1990 Corvette: Service Bulletin: SIR Diagnostics and Procedures to Prevent Codes 16 and 26 Due to Corrosion Revised

Subject: SERVICE MAN. UPDATE SEC.9J A/B REV. SIR DIAGNOSTIC PROCEDURE

Model and Year: 1990 CORVETTE

Bulletin Number: 90-436-9J - (11/07/1991)

FORWARD DISCRIMINATING SENSORS Figures 1 & 2 -----

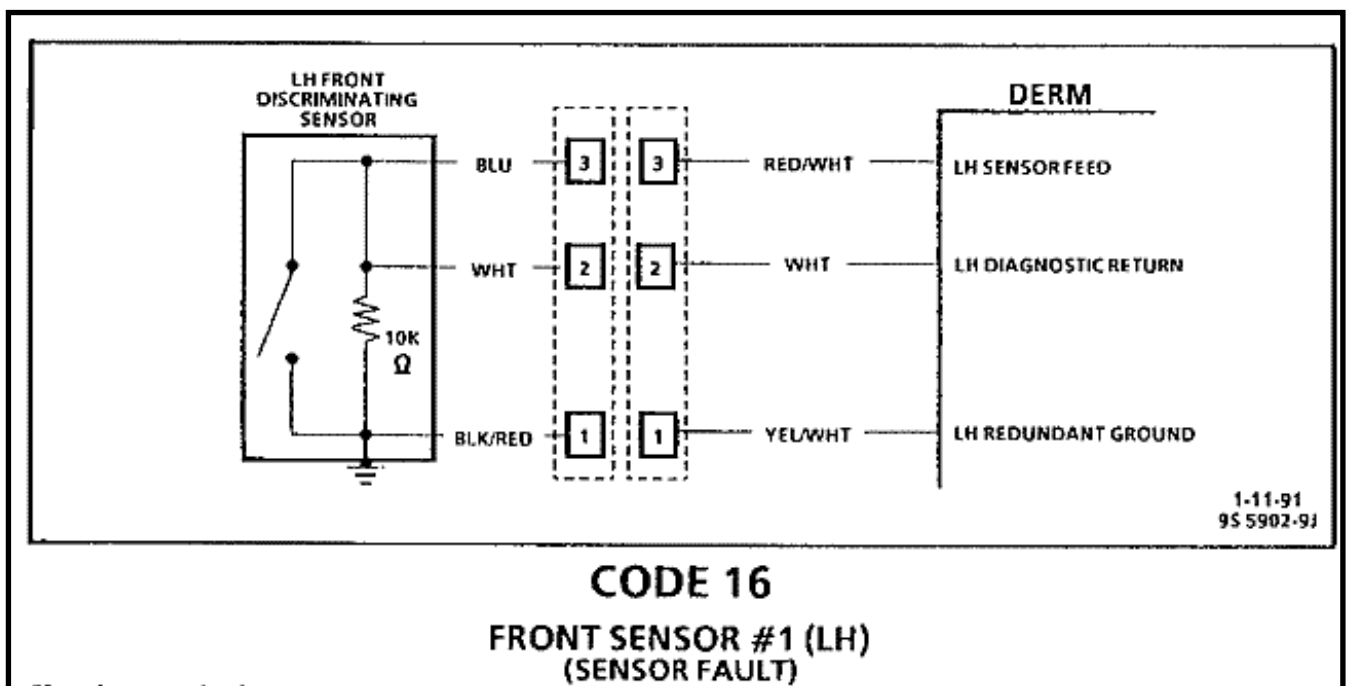
Caution should be used to assure proper location of sensors to the front frame rails. The keying of the sensors to the frame rails through the differently sized mounting bolt holes in the sensor mounting plate should never be modified in the field.

- Proper operation of the forward discriminating sensor requires the sensor be rigidly attached to the vehicle structure and that the arrow on the sensor be pointing toward the front of the vehicle.

1. Apply a thin layer of special grease P/N 12345579 to the frame rail mounting surface and the mounting flange of the sensor. Do not apply the grease to the mounting bolts or holes.
2. Forward discriminating sensor, with arrow pointing toward front of vehicle.
3. External tooth lock washers, P/N 11501869 (8 mm) and 121753 (6 mm) to mounting bolts.
4. Sensor mounting bolts. Ensure that washers are between bolt head and sensor mounting flange, not between mounting flange and frame rail.

- Front (13 mm head) bolt to 25 N.m (19 lb. ft.) - Rear (10 mm head) bolt to 14 N.m (125 lb. ft.)
5. Sensor electrical connection, then clip completed connection into retainer.
 6. Position windshield washer reservoir; install retaining bolts.

CODE 16 FRONT SENSOR #1 (LH) (SENSOR FAULT)

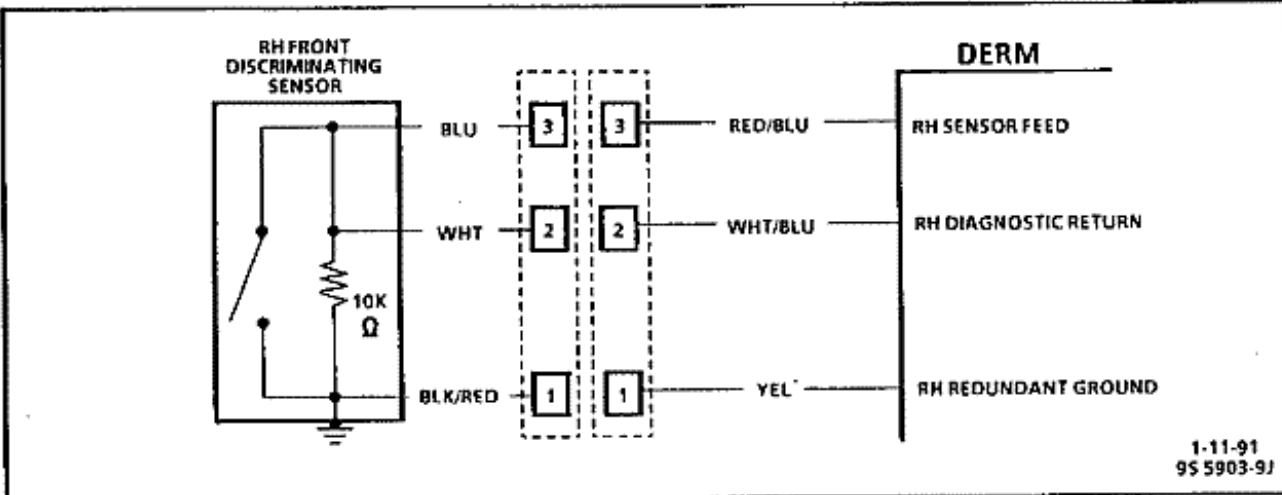
- 1
- IGNITION "OFF."
 - DISCONNECT SENSOR CONNECTOR.
 - USING ADAPTERS FROM J 37808-10 AND DVM J 34029-A OR DVM J 39200, MEASURE THE RESISTANCE BETWEEN TERMINALS IN THE SENSOR PIGTAIL CONNECTOR AS SHOWN BELOW. NOTE MEASUREMENTS FOR EACH CHECK.

SENSOR TERMINALS	RESISTANCE
1 AND 2	ABOUT 10,000 Ω
1 AND 3	ABOUT 10,000 Ω
2 AND 3	LESS THAN 1 Ω

- 2
- REPEAT RESISTANCE MEASUREMENTS IN STEP 1 WHILE "WIGGLING" WIRING AND CONNECTORS. THIS MAY UNCOVER AN INTERMITTENT FAULT WHICH DOES NOT APPEAR DURING STEP 1.
 - WERE ANY INTERMITTENTS NOTED?

- 3
- REMOVE SENSOR; REFER TO "LEFT SENSOR" ON ATTACHED PAGES.
 - CLEAN ANY PAINT AND/OR CORROSION FROM SENSOR AND FRAME RAIL MOUNTING POINTS AND MOUNTING BOLTS.
 - INSTALL SENSOR; REFER TO "LEFT SENSOR" ON ATTACHED PAGES TO APPLY SPECIAL GREASE AND LOCK WASHERS UPON INSTALLATION TO HELP PREVENT RECURRENCE OF CODE 16 DUE TO CORROSION.
 - CLEAR CODES (TECH 1 PREFERRED).
 - IGNITION "OFF," THEN "ON."
 - DOES CODE 16 RESET?

- 4
- REMOVE SENSOR; REFER TO "LEFT SENSOR" ON ATTACHED PAGES.
 - CLEAN ANY PAINT AND/OR CORROSION FROM FRAME RAIL MOUNTING POINTS AND MOUNTING BOLTS.
 - INSTALL NEW SENSOR; REFER TO "LEFT SENSOR" ON ATTACHED PAGES TO APPLY SPECIAL GREASE AND LOCK WASHERS ON INSTALLATION TO HELP PREVENT RECURRENCE OF CODE 16 DUE TO CORROSION.
 - CLEAR CODES (TECH 1 PREFERRED).
 - IGNITION "OFF," THEN "ON."
 - DOES CODE 16 RESET?
